**TOWN OF PORTOLA VALLEY  
ARCHITECTURAL AND SITE CONTROL COMMISSION (ASCC)  
Monday, November 23, 2015  
7:00 PM – Regular ASCC Meeting  
Historic Schoolhouse  
765 Portola Road, Portola Valley, CA 94028**

# MEMORANDUM

**RE:** Architectural Review for an Addition and Major Remodel and a New Swimming Pool, File # 18-2014, 180 Golden Oak Drive, Kunkel Residence

**TL402SCS**  
Specular Clear Reflector with Solite® Glass Lens, White Ring

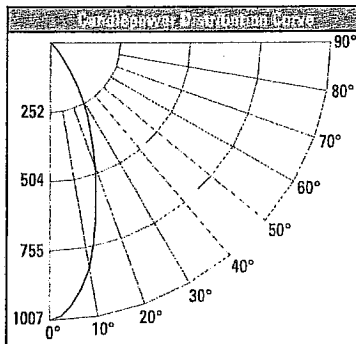
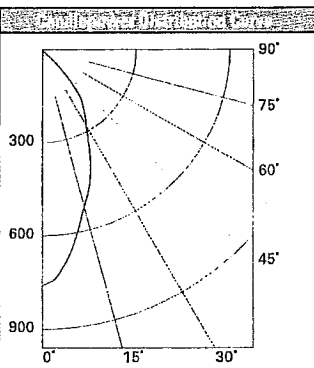
The proposed exterior lighting for the residence is shown on Sheets A1.5 and A1.6 and cut sheets are provided on Sheet A0.5. The proposed recessed downlight is to have a white ring which is not compliant with Town regulations, and an alternate color that meets the 50% light reflectivity limit will need to be selected. In general, the numbers and locations of proposed lighting on the home appear in compliance with Town lighting guidelines, although one downlight could be eliminated along the front entry and one or two downlights could be eliminated along the rear, main level deck (Sheet A1.6). There are four wall lights proposed at the roof terrace. There are existing floodlights on the home, and these will be removed with the renovation.

## LL: Underwater Light

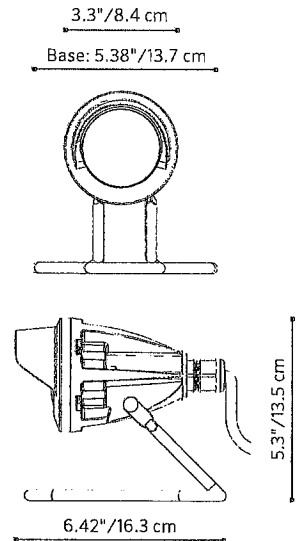
Landscape lighting is presented on Sheet L1.1 and appears to be in general compliance with Town lighting guidelines. There are two underwater lights proposed for the water feature at the home's entry, and these are typically discouraged by the Town. There is one light proposed for the spa and one light proposed for the pool.

LANDSCAPE  
**PLANTING PLAN**

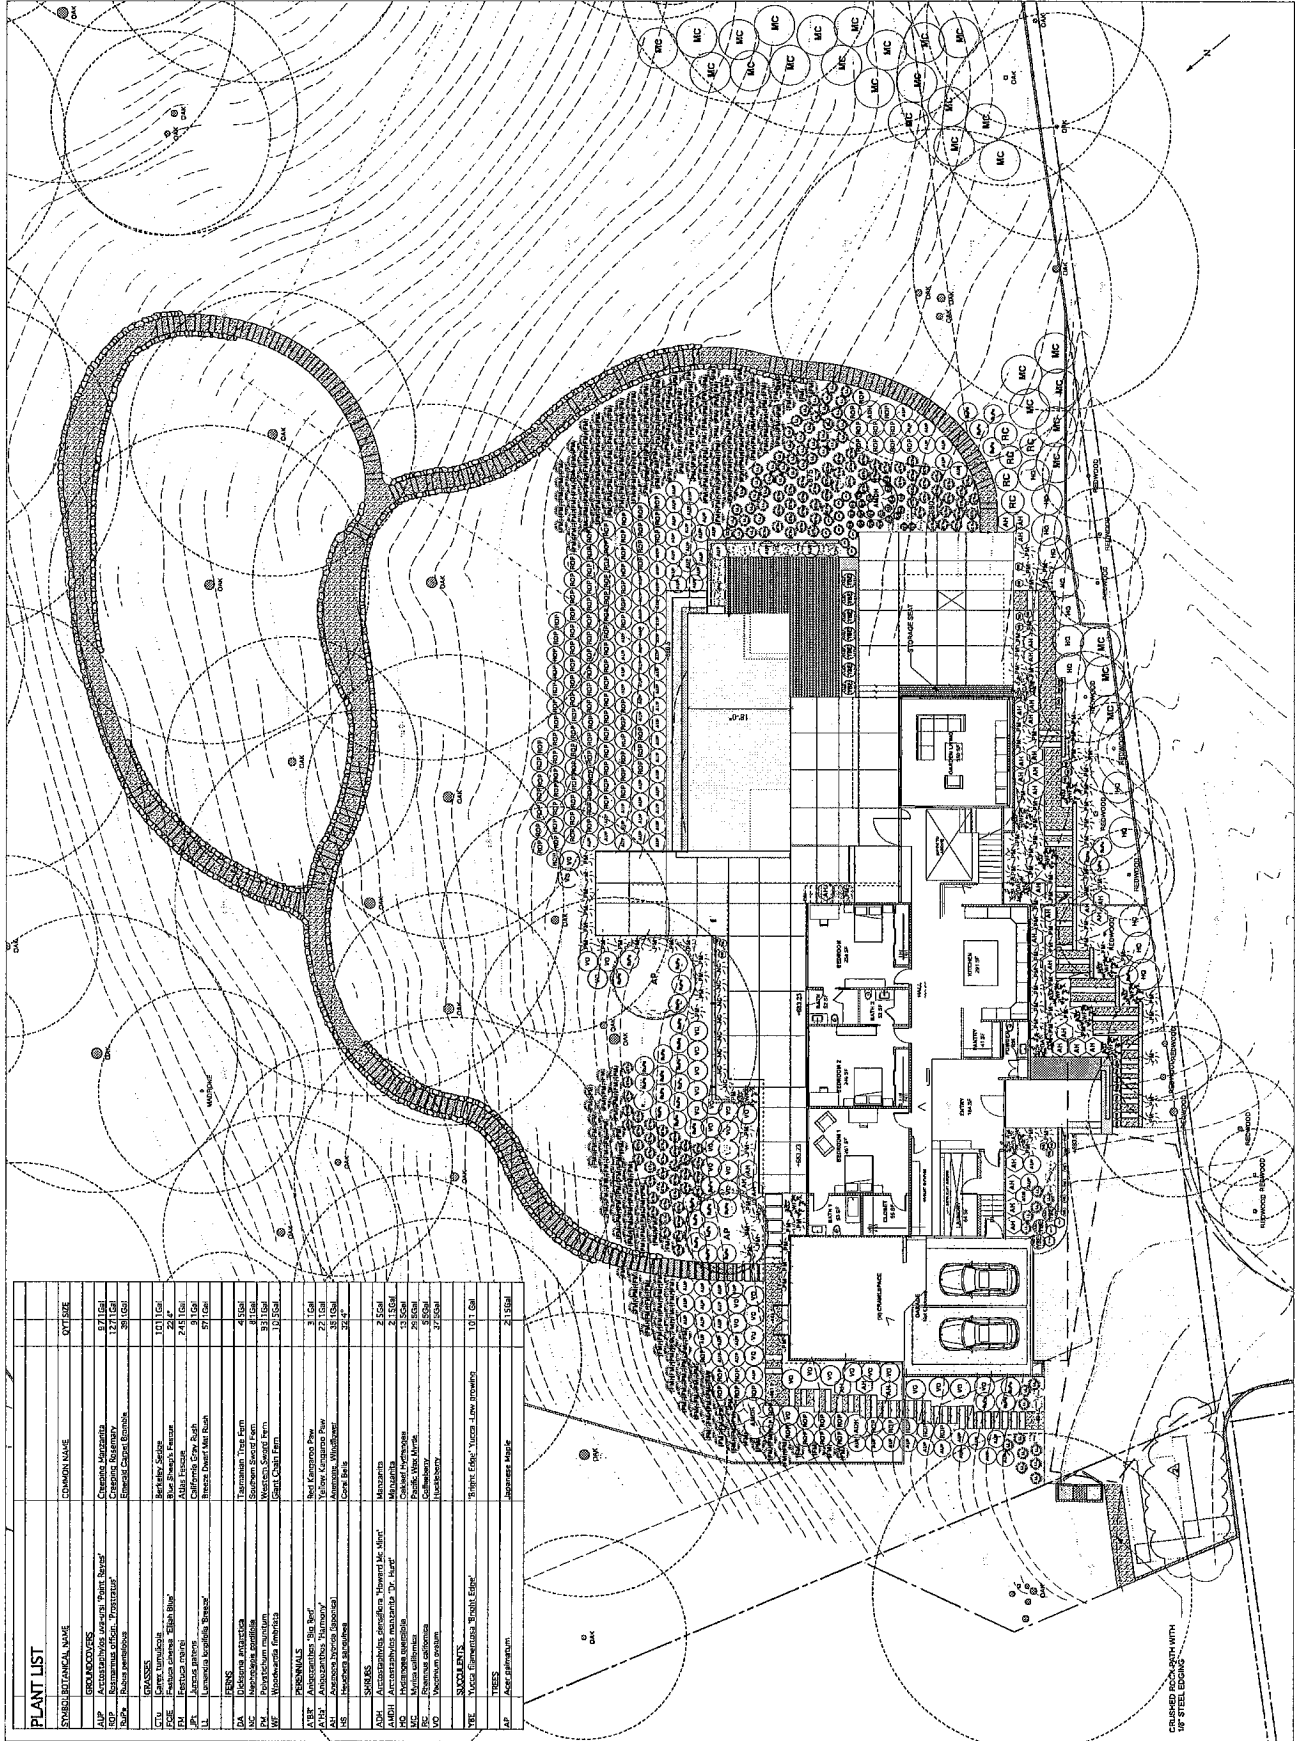
The proposed planting (Sheet L4.0), while generally located in close proximity to the home and improvements, appears somewhat dense overall. Town planting guidelines support natural

landscape solutions with random groupings and less linear forms. Some overall thinning of the proposed materials would allow new plantings to blend more naturally with existing site conditions. Twenty 5-gallon *Myrica californicas* are proposed south of the residence to provide screening between the site and the home at 155 Bear Gulch. The placement of screen planting in this location appears appropriate; however, the plantings may be more effective if they were reduced in number, clumped in a more natural fashion and increased in size, particularly as the plantings flow downslope. Additionally, consideration might be given to adding another plant species within this screening so as not to create a hedge of *Myrica californica*.
